**TYPE III –CONDITIONAL USE, SITE PLAN AND DESIGN REVIEW, VARIANCES
STAFF REPORT AND RECOMMENDATION**

FILE NUMBER: SP 17-40: Site Plan and Design Review
CU 17-02: Conditional Use
VR 17-02: Variance for Site Layout/Configuration
VR 17-03: Variance for Building Exterior

REQUEST: The applicant submitted a Site Plan and Design Review, Conditional Use, and two Variance applications to construct a new fire station within the “C” General Commercial District.

LOCATION: 19340 Molalla Avenue, Oregon City, Oregon 97045
Clackamas County Map 3-2E-9B, Tax Lot 1601

Figure 6: Proposed Site Plan

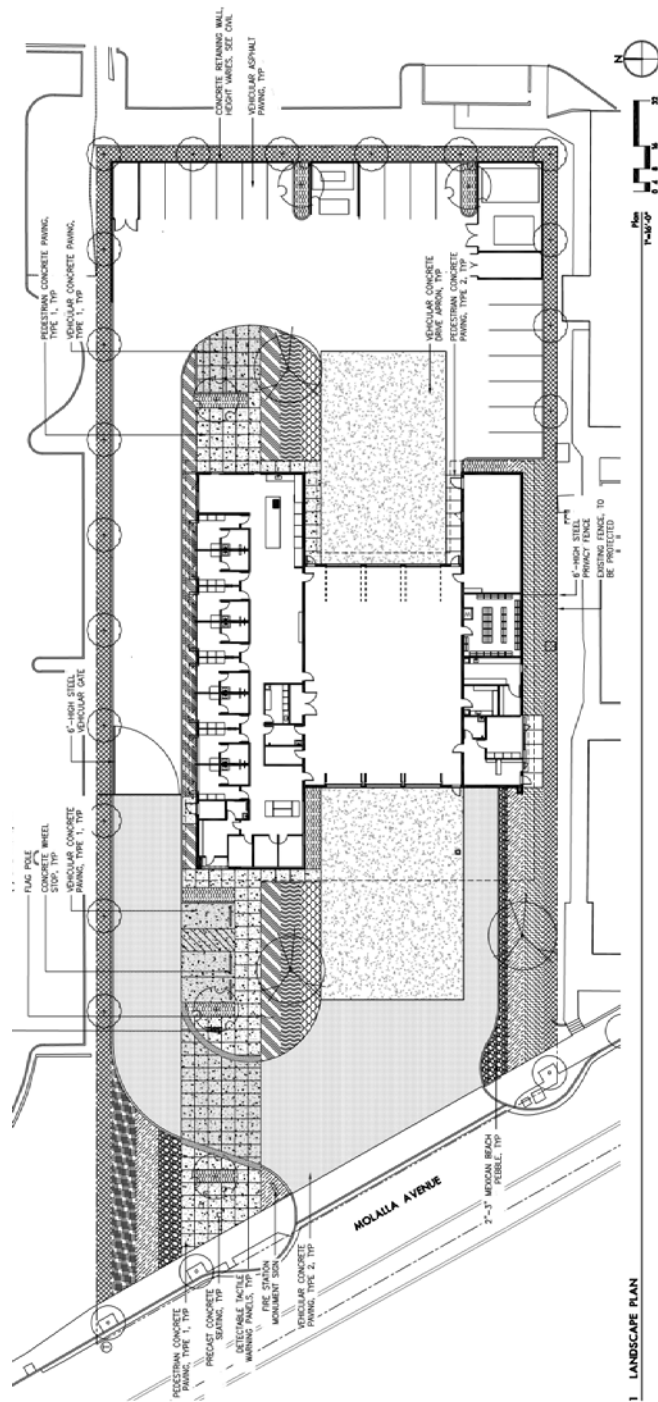
Finding: Complies as proposed. The pedestrian circulation system will connect the principal building entrance to the adjacent commercial sites by utilizing an enhanced walkway system connecting to the existing sidewalk system along Molalla Avenue. Connections to adjacent properties are limited due to the security and desired efficiency needed in order to provide the public with adequate emergency response times.

Staff has found that the proposed pedestrian walkway intersects with the portion of the driveway where the emergency vehicles would gain access on to Molalla Ave. The applicant shall provide a cross section of the subject area to the Oregon City Planning Division for planning staff to ensure this portion of the site has been proficiently marked.

1. All water and sanitary facilities shall be designed to meet City's design standards.
2. The existing pedestrian path across the driveway and the pedestrian ramps on each side shall meet ADA requirements.

Variance related to Site Design/Configuration.

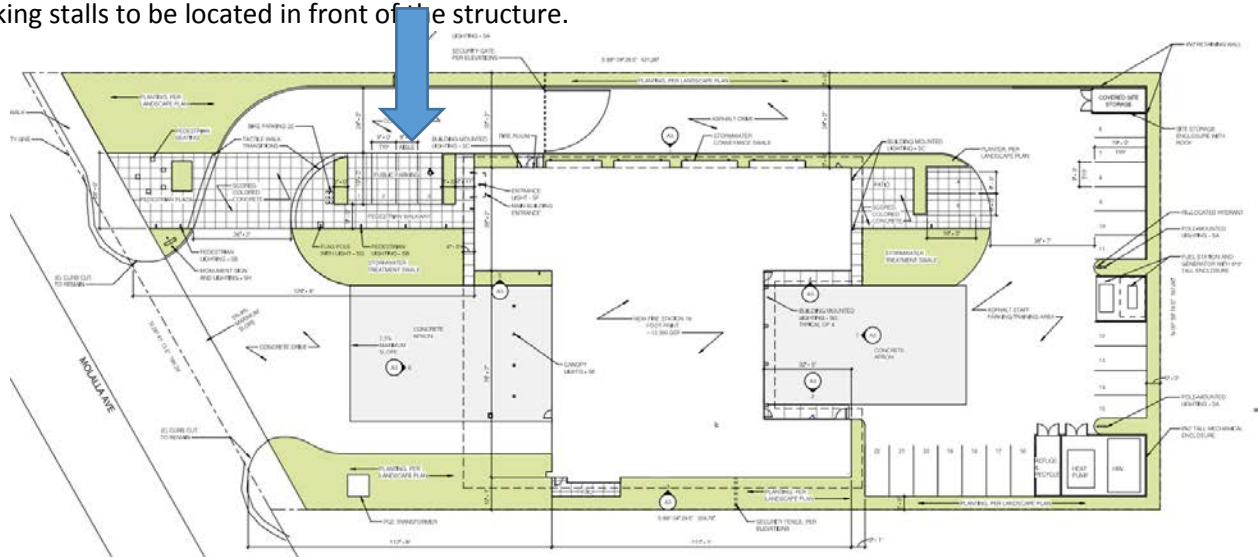
Variance to allow the building to be setback from the Molalla Avenue frontage, and allowance of three (3) parking stalls to be located in front of the structure.
